Product Change Notification

Product Change Notification: PCN-24-201442 **PCN Date:** 04-MAR-24

Product Description: (Text limited to 120 characters)
T9A, T9E series relay.

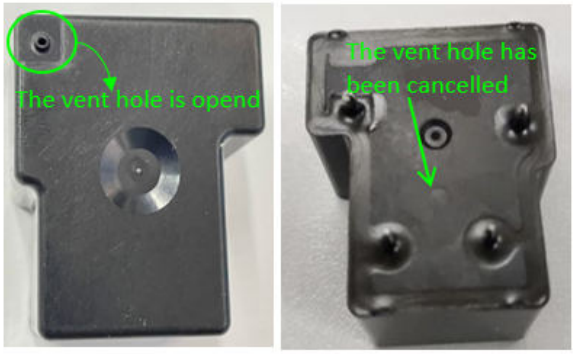
General Description of Changes
Dear customers, please be aware of an upcoming feature change to the listed T9A/T9E part numbers with the new melted sealing technology, there is no impact on the product performance with the change. You can see comparison details in the below PCN images table. Before:1. For the sealed type, the nib is at the top corner of the case normally closed, and use UV glue to seal the vent hole on the base finally. 2. For the vented type, the nib is at the top corner of the case normally closed and the vent hole is at the bottom of the base normally opened . After: 1. For the sealed type, use melting sealing technology to seal the vent hole on the case finally, not use UV glue further and cancel the vent hole on the base. 2. For the vented type, it's a opened nib vent hole and cancel the vent hole on the base.

1. For the sealed type, use melting sealing technology to seal the vent hole on the case finally, not use UV glue further and cancel the vent hole on the base. 2. For the vented type, it's a opened nib vent hole and cancel the vent hole on the base. Vented type:
